Accessibility Survey

City of Downey Orizaba Avenue - Borson Street To Imperial Highway

Disability Access Consultants

Sidewalk North Of Cole Street @ 33.933280606993, -118.141557276249

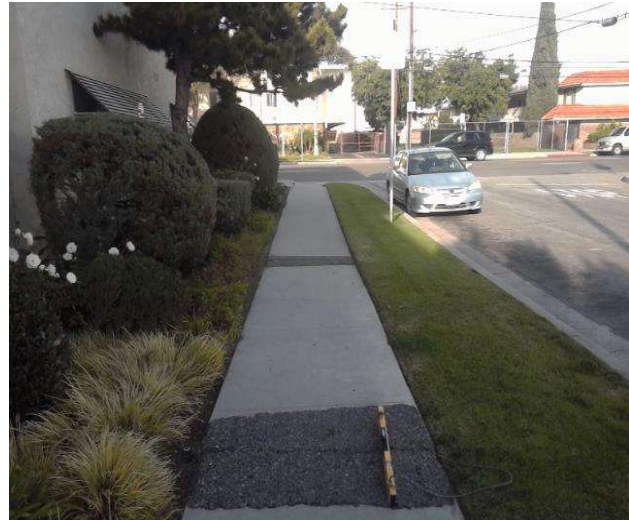
Sidewalk cross slope is not compliant.

On-Site Finding 3.20 percent for 2.50 feet

Notes : Surface is rough and uneven for 2.5 feet.

Repave the sidewalk surface with the recommended cross slope.

Recommendation Up to 2.08 percent

Sidewalk North Of Cole Street @ 33.933280606993, -118.141557276249

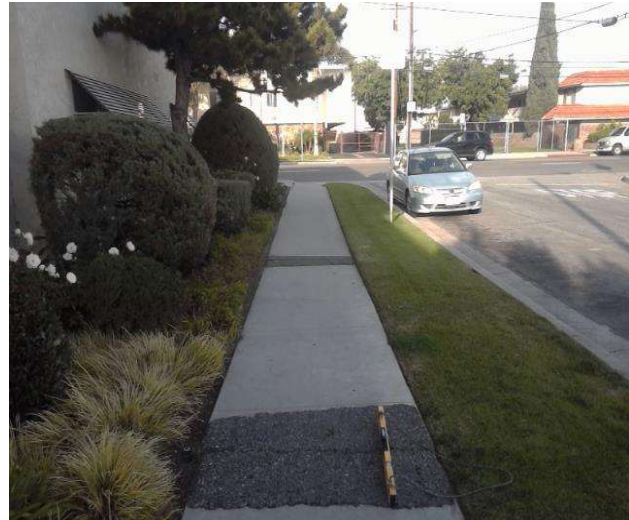
Sidewalk running slope is not compliant.

On-Site Finding 14.40 percent for 2.50 feet

Notes : Surface is rough and uneven for 2.5 feet.

Repave the sidewalk surface with the recommended running slope.

Recommendation Up to 5.00 percent

Sidewalk North Of Cole Street @ 33.933310649849, -118.141525089741

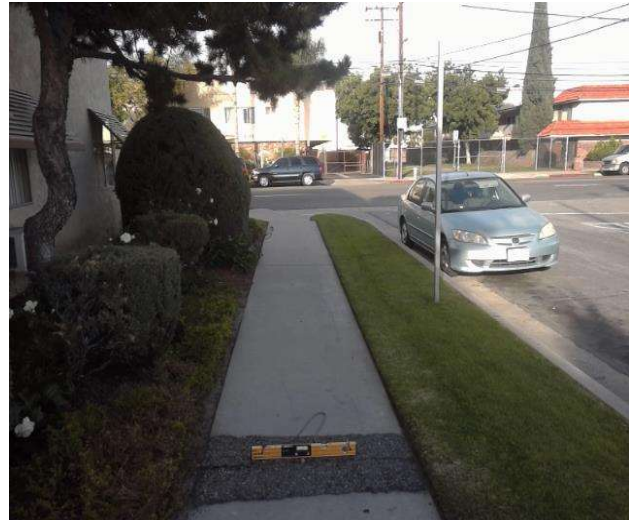
Sidewalk cross slope is not compliant.

On-Site Finding 3.10 percent for 37.00 feet

Notes : Surface is rough and uneven for 2 feet.

Repave the sidewalk surface with the recommended cross slope.

Recommendation Up to 2.08 percent

West Side @ 33.960398314595, -118.120960593224

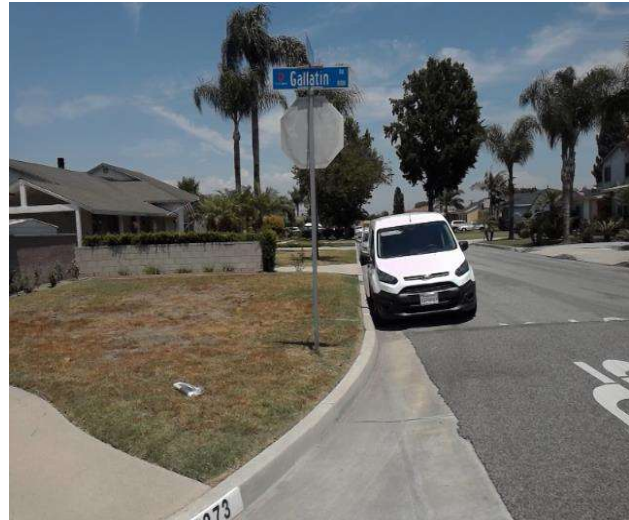
No sidewalk exists at the location.

On-Site Finding Not Found

No action necessary until a sidewalk is provided.

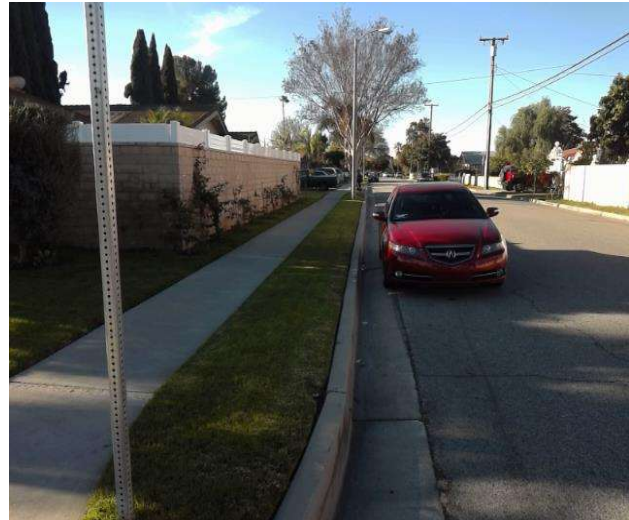
There is no 60X60 turn area at every 200 feet.

On-Site Finding Not Found

Provide a 60X60 turn every 200 feet on the sidewalk.

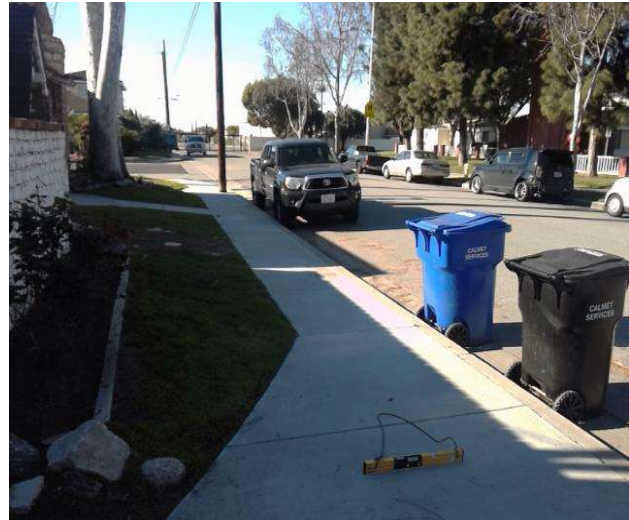
Sidewalk does not have enough width.

On-Site Finding 47.00 inches for 72.00 feet

Widen the sidewalk to the recommended value.

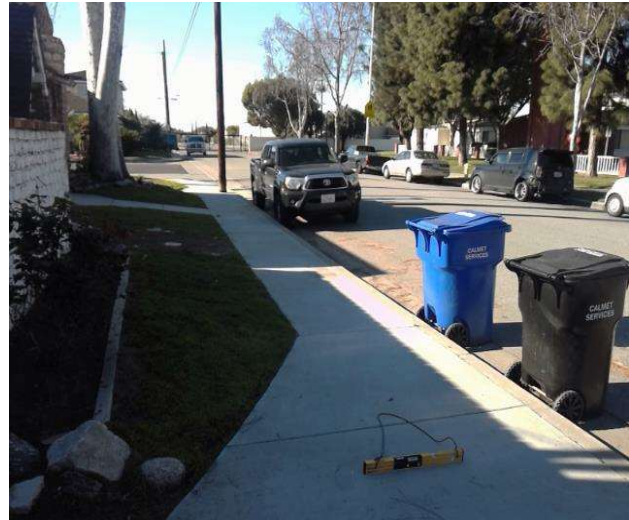
Sidewalk cross slope is not compliant.

On-Site Finding 4.80 percent for 51.00 feet

Repave the sidewalk surface with the recommended cross slope.
